# **Lidsdale Ash Dam Areas**

## **Construction and Operational Transport Management Plan**

E230337 RP3

**Table 1.3 TfNSW comments and EMM responses**

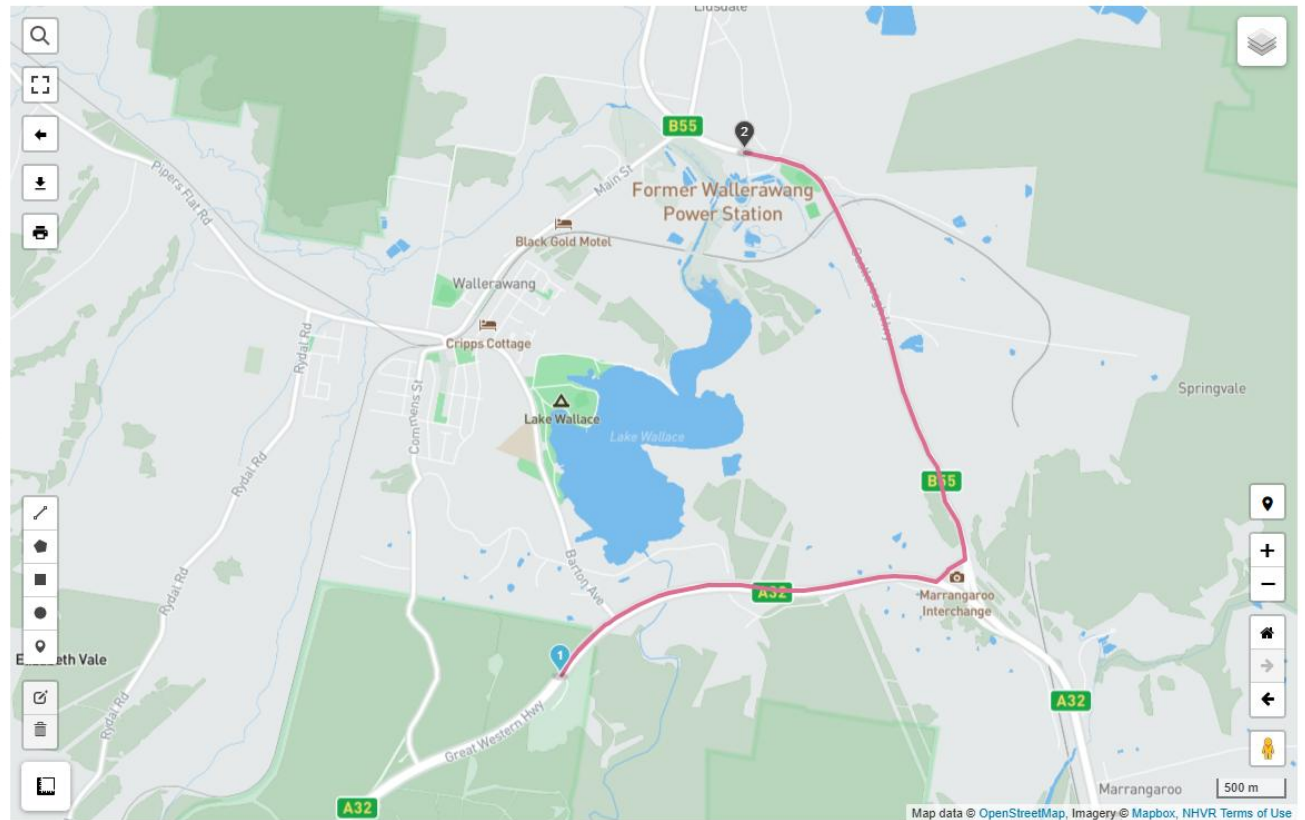
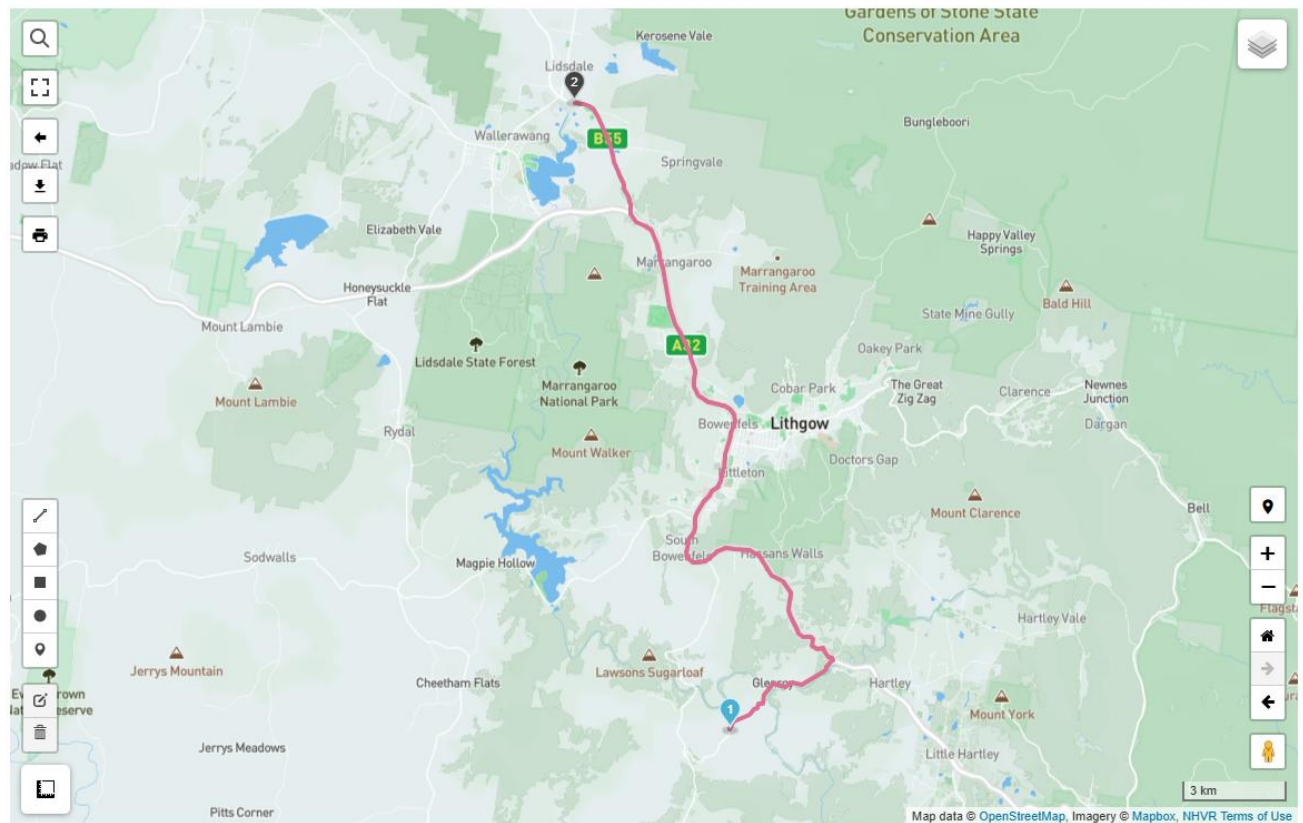
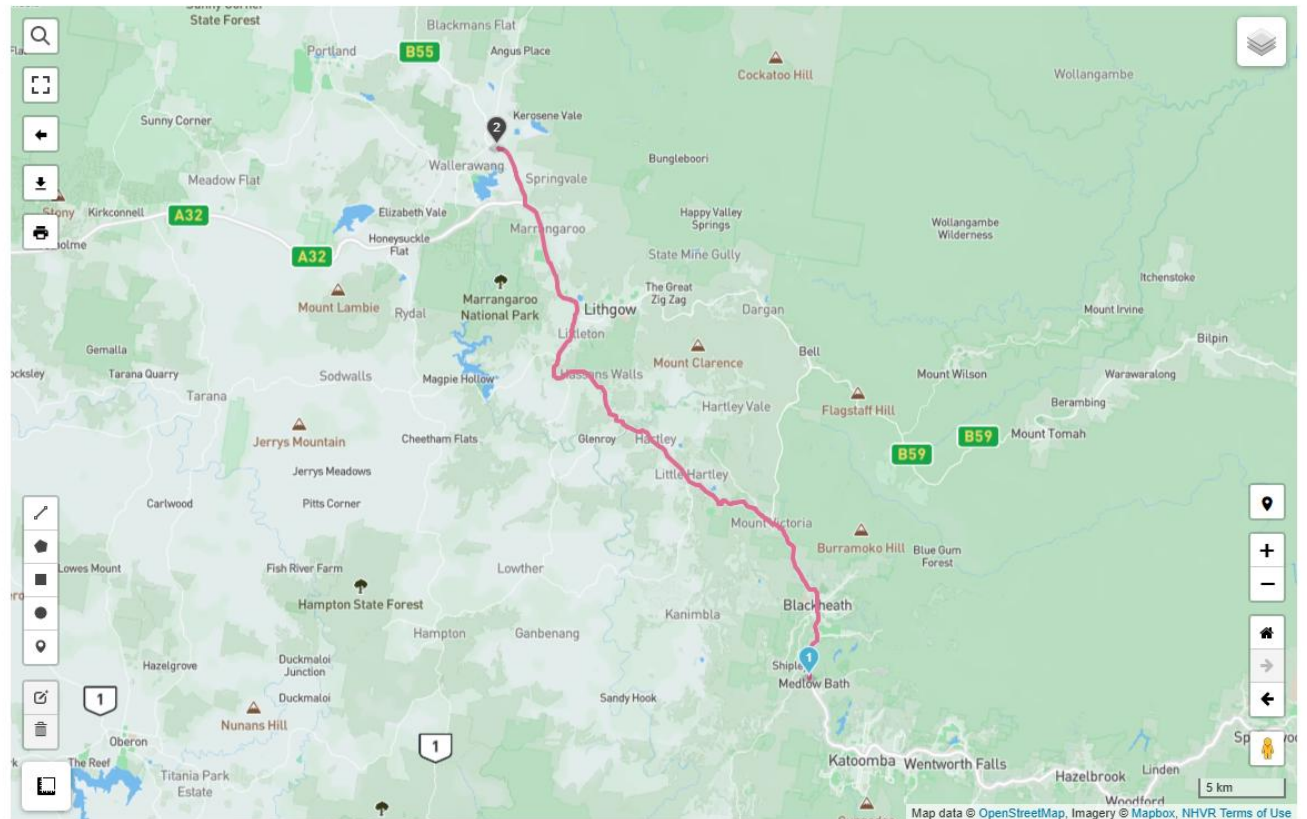
1	The COTMP does not provide details on proposed haulage routes to transport the capping material associated with the operations of the development. Whilst the plan states that haulage routes will be provided once engagement with a transport contractor has occurred, it only demonstrates the internal haulage route from the existing site access road. TfNSW are required to assess the potential impacts to the broader classified road network in the context of the proposal. Accordingly, proposed haulage routes should be clearly illustrated in the COTMP in accordance with Condition 6.3(a) within the consent and identify any sensitive land uses (e.g. school zones, residential areas) impacted by the vehicle movements and consider any conditions contained within the existing approval. (i.e. Condition 2.36(a) indicates that no capping material is to be transported via any residential roads within the Lithgow local government area (LGA) during construction and operation phase).	Section 2.6 has been updated to provide further details and to describe the process for determining haulage routes for new suppliers. Example haulage routes of key suppliers have been included as Attachment D.
